**CITY OF SEATTLE  
ANALYSIS AND DECISION OF THE DIRECTOR  
OF THE DEPARTMENT OF PLANNING AND DEVELOPMENT**

**Project Number:** 3012729  
**Applicants Name:** Paul Buchanan  
**Address of Proposal:** 133 14<sup>th</sup> Avenue East

Land Use Application to allow a four-story, 42 unit residential building over four live-work units. Parking for 24 vehicles located below grade. Existing structure to be demolished.

MASSING OPTION A

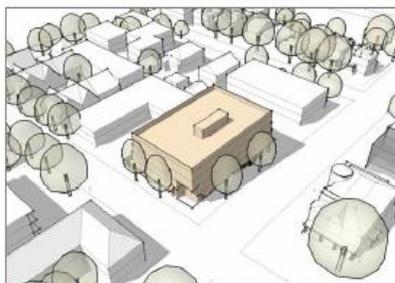
The first scheme (Option A) showed a rectangular building mass with articulation of the corner base.

MASSING OPTION B

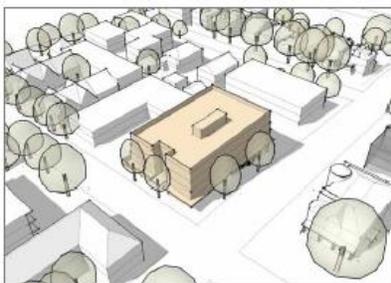
The second scheme (Option B) showed a rectangular massing with a vertical notch on the east side facing 14th Avenue and a ground level entry courtyard.

MASSING OPTION C - PREFERRED SCHEME

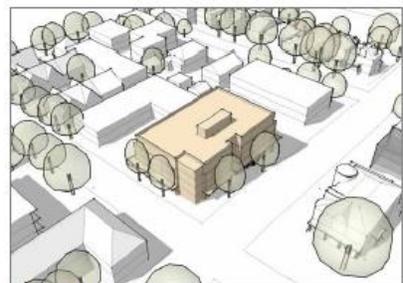
The third and preferred scheme (Option C) showed a rectangular massing with corner articulation and a vertical notch along the John Street facade.

At the Early Design Guidance Meeting, the Board agreed that the corner location is important and that the preferred alternative provides a solid corner expression. The transition between the building mass and the ground level design and proposed live/work uses will be a crucial issue to review at the next meeting. How the corner expression relates to the rest of building body flanking the corner is also essential. The Board also noted that the proposed development should take advantage of the topographical changes of the site's location and views.

At the Early Design Guidance Meeting, the Board noted that the vertical modulation shown in the preferred option, along with high quality materials and a strong architectural design concept and the full required setback along the south side of the site would provide a sensitive transition to the zone edge. The Board was supportive of the building massing above the ground level and encouraged interesting roof lines, reminiscent of the varied roof lines found in the neighborhood context. The Board was pleased with the step back of the top floor, which give an appropriate transition between the scale of this building and the environs.
